DA-B DRAWINGS AMENDED AS SHOWN CLOUDED 29/01/2018 Y T AHM DA-A ISSUED FOR DEVELOPMENT APPLICATION 03/08/2017 Y T **AMENDMENT**

MIXED USE DEVELOPMENT 4-14 Mark St Lidcombe, NSW 2141

**REVISION B:** - Fire stairs relocated to north eastern corner

Roof Plan

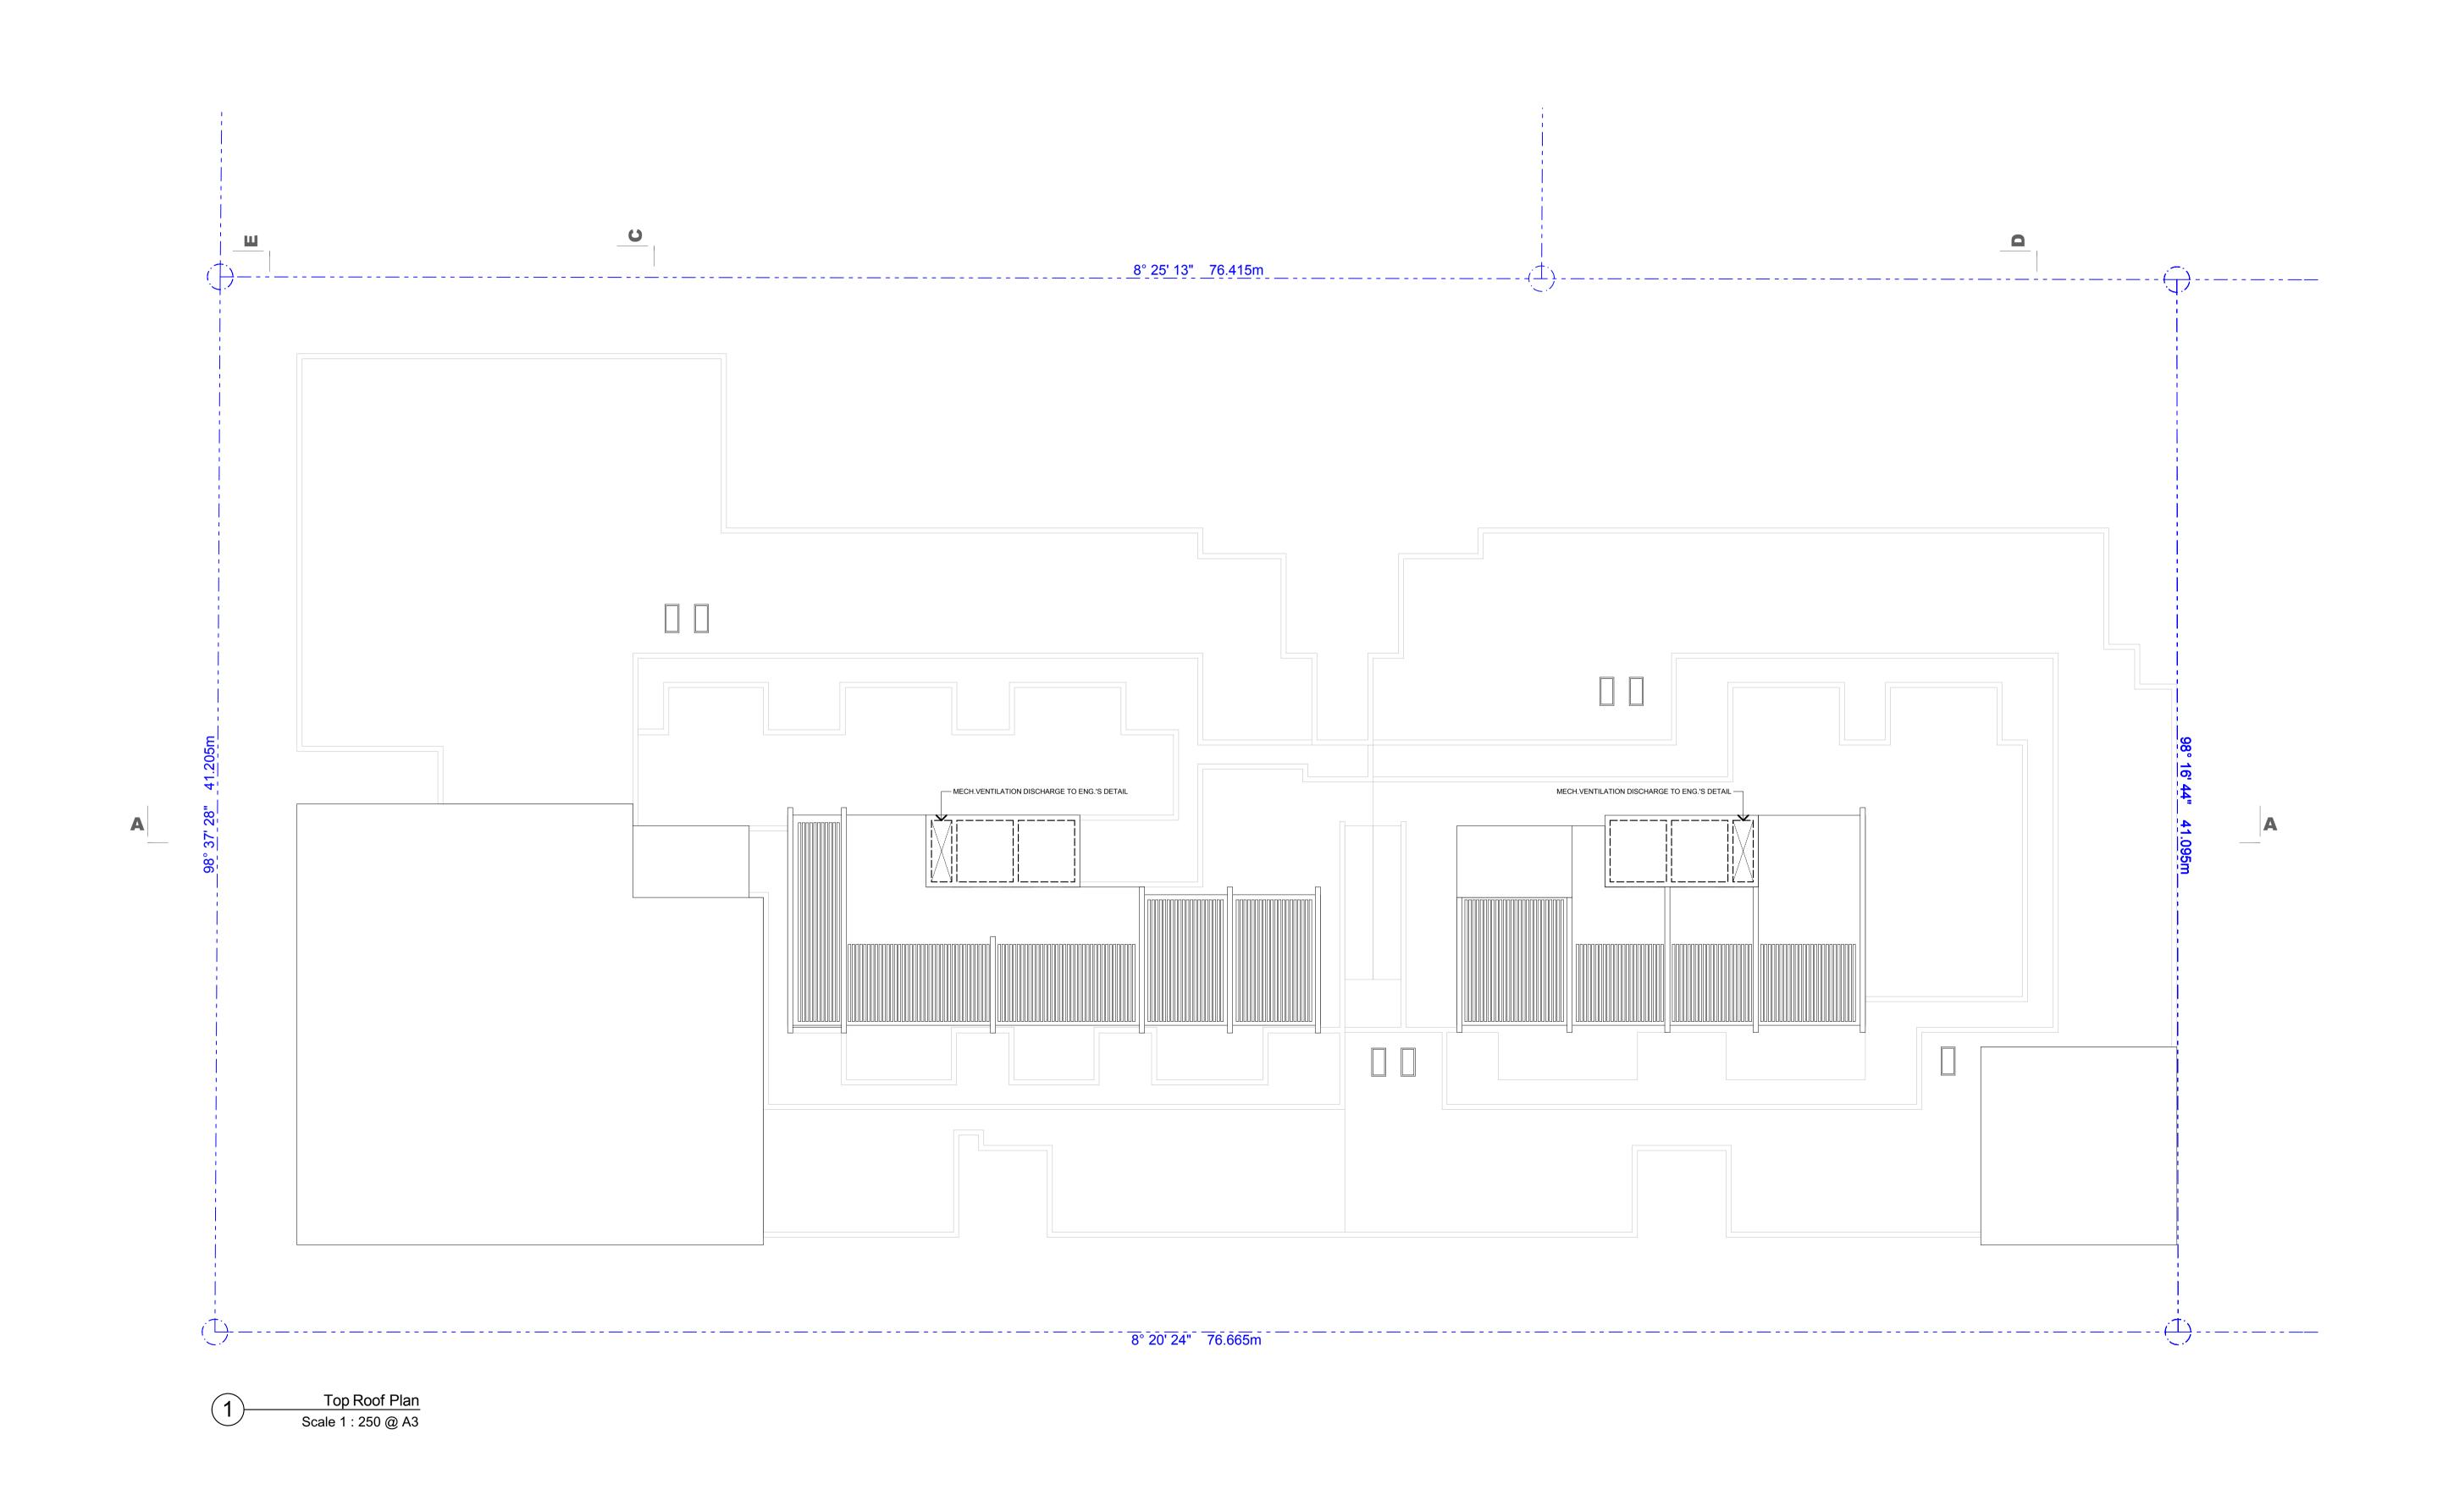
REVISION B : - Add rooftop terrace COS to tower-B, connected by accessible ramps to tower-A rooftop terrace - Floor RL's raised by 500mm

## Top Roof Plan

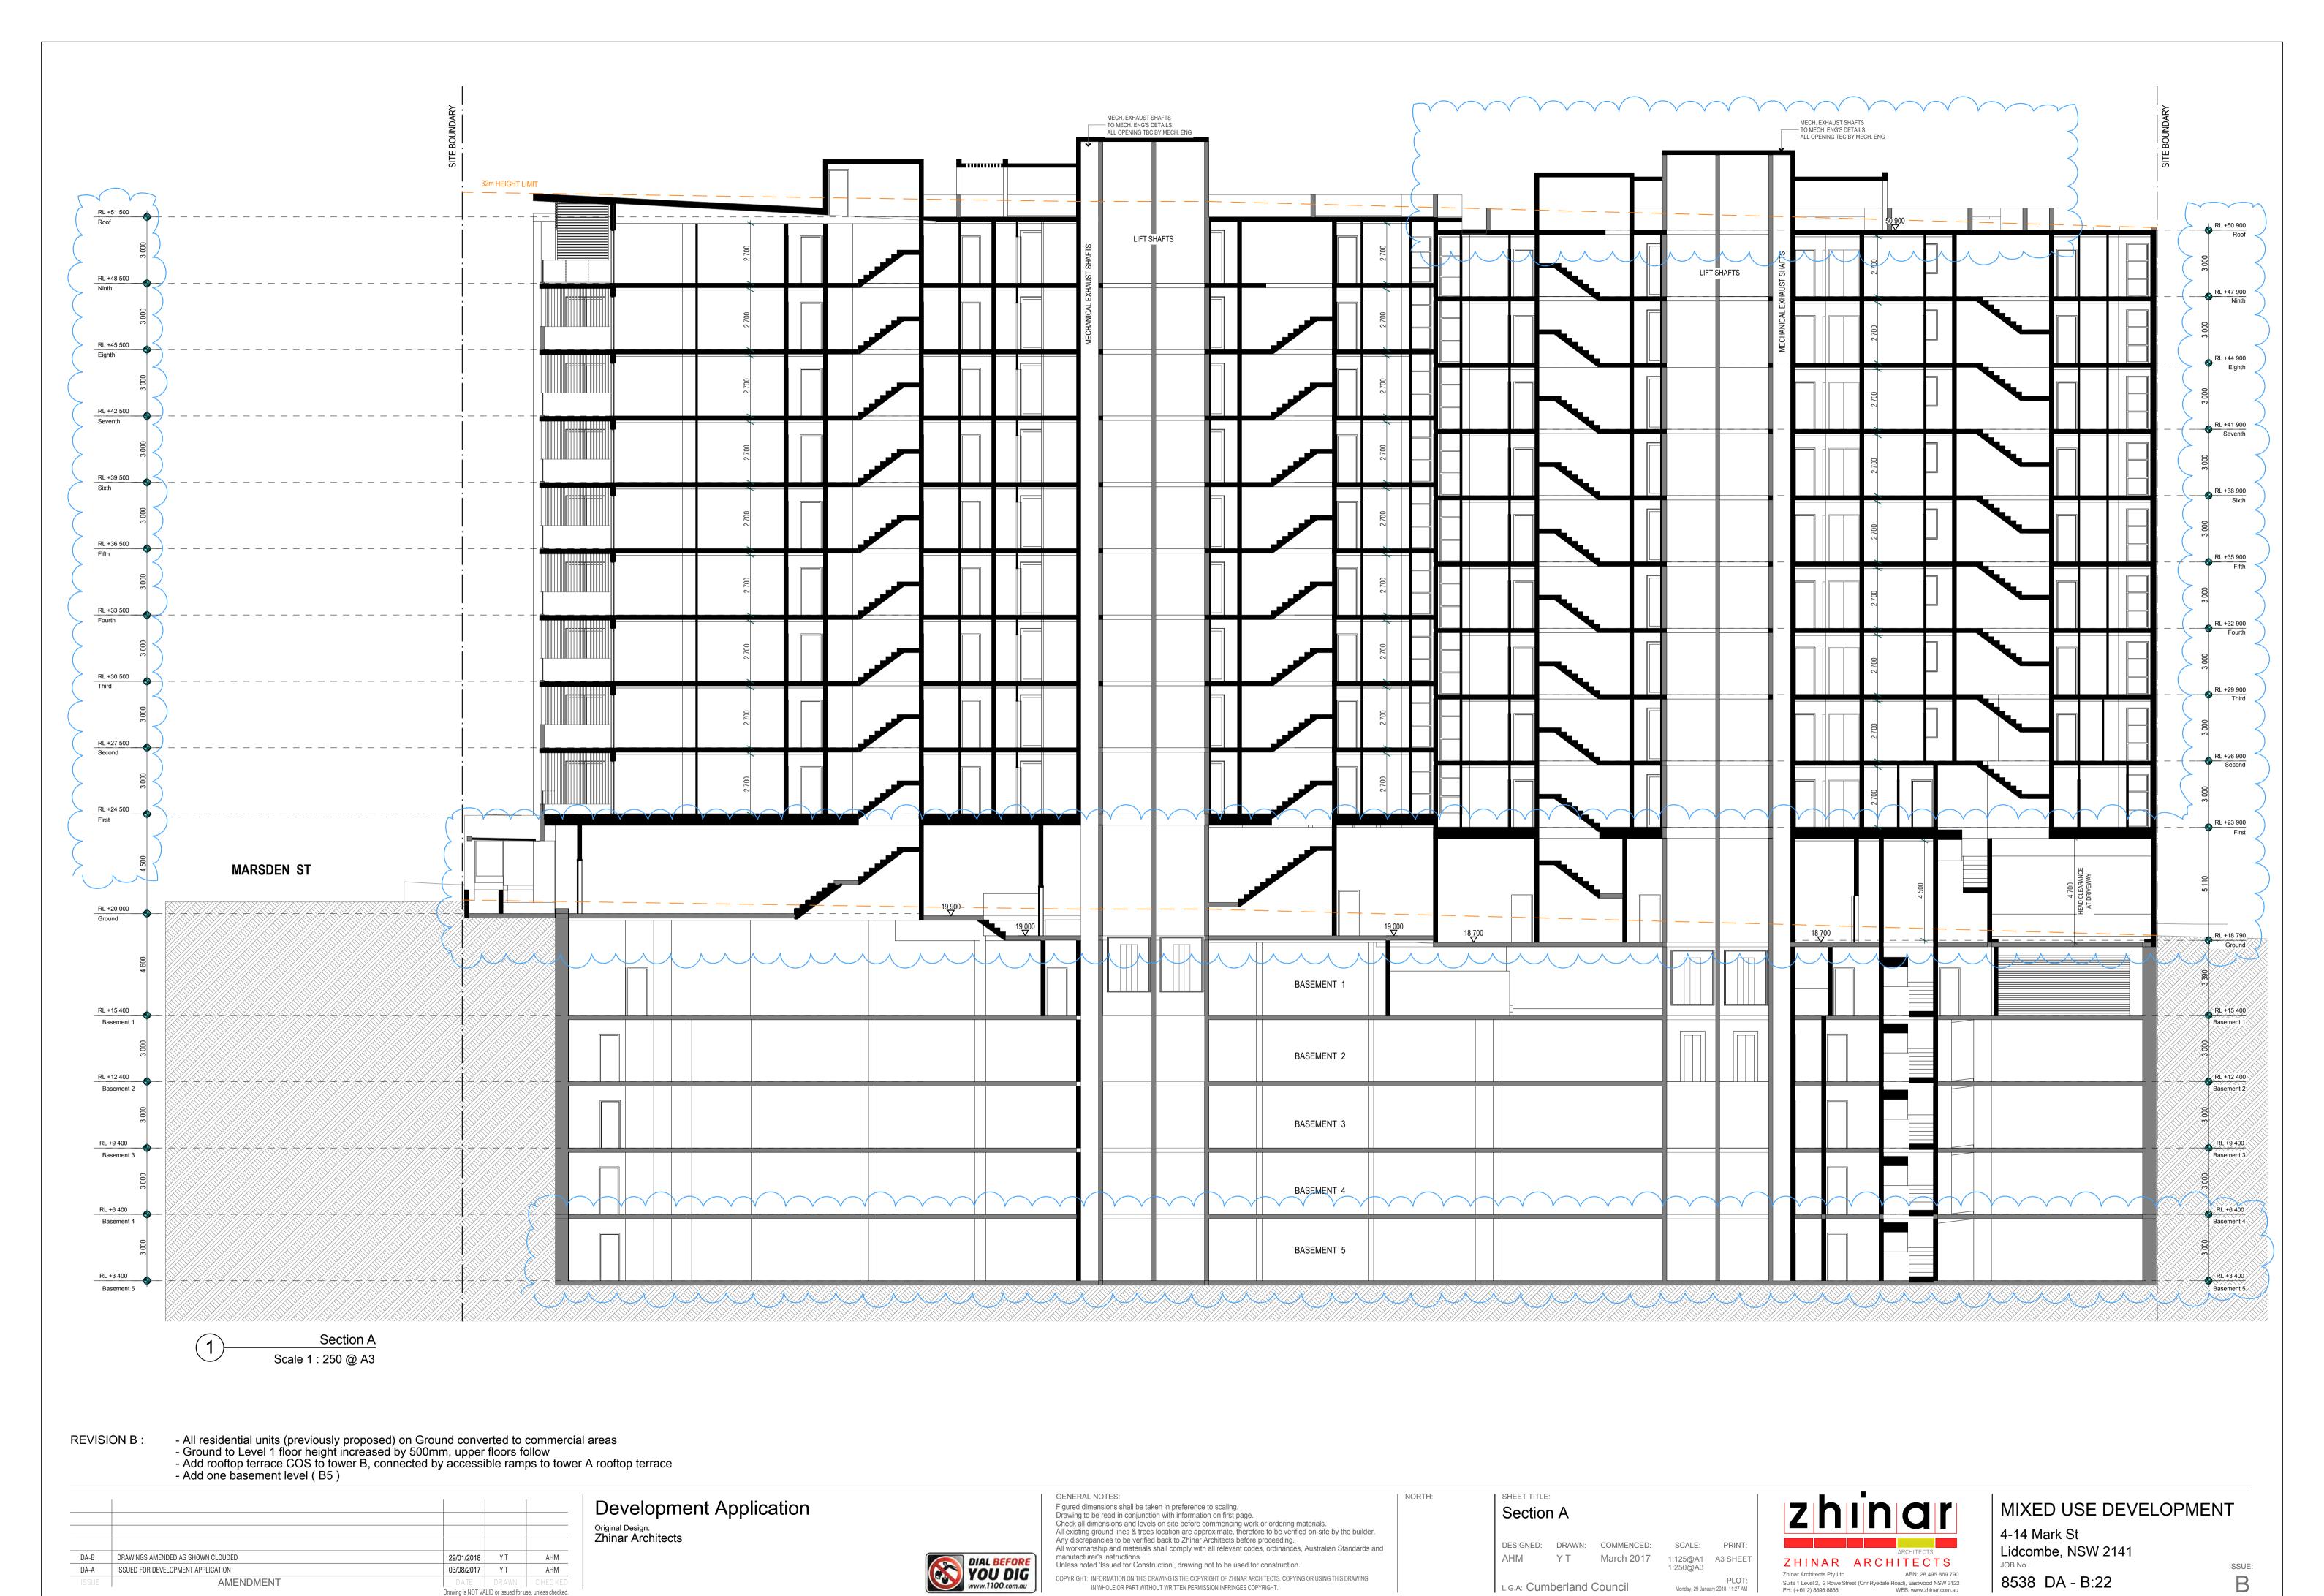
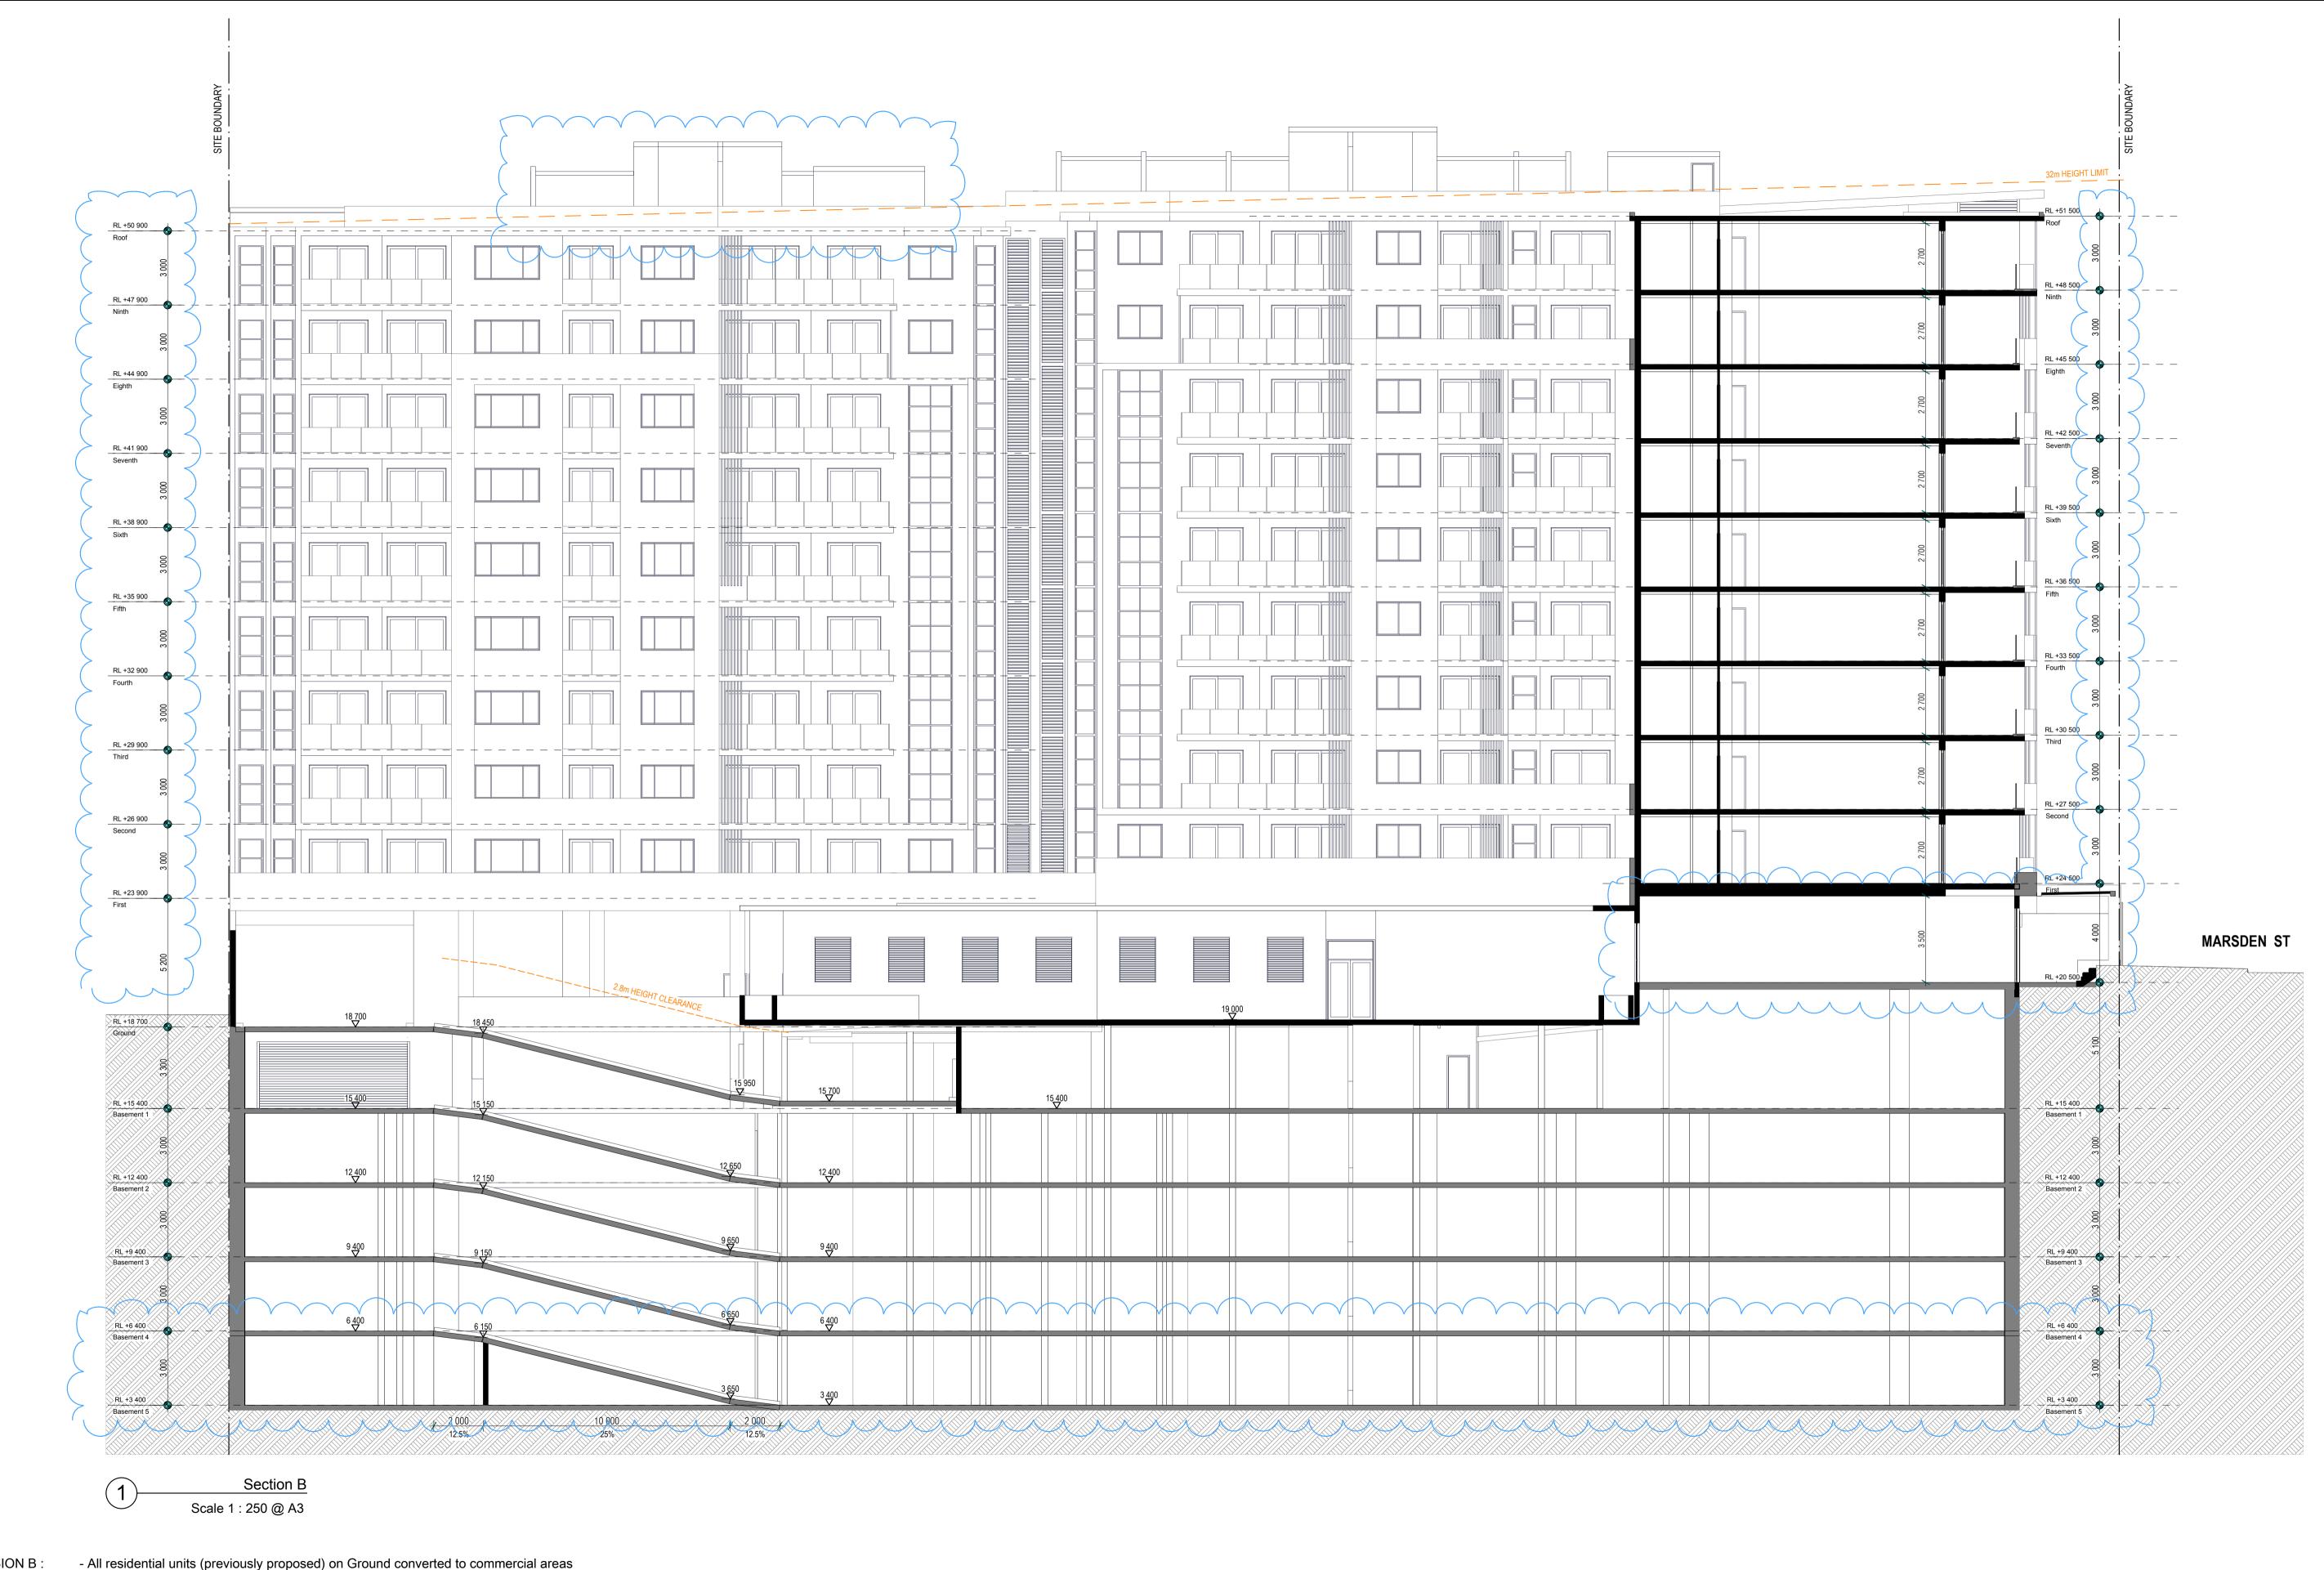
Add rooftop terrace COS to tower-B and connected to tower-A rooftop terrace
 Floor RL's raised by 500mm **REVISION B:**
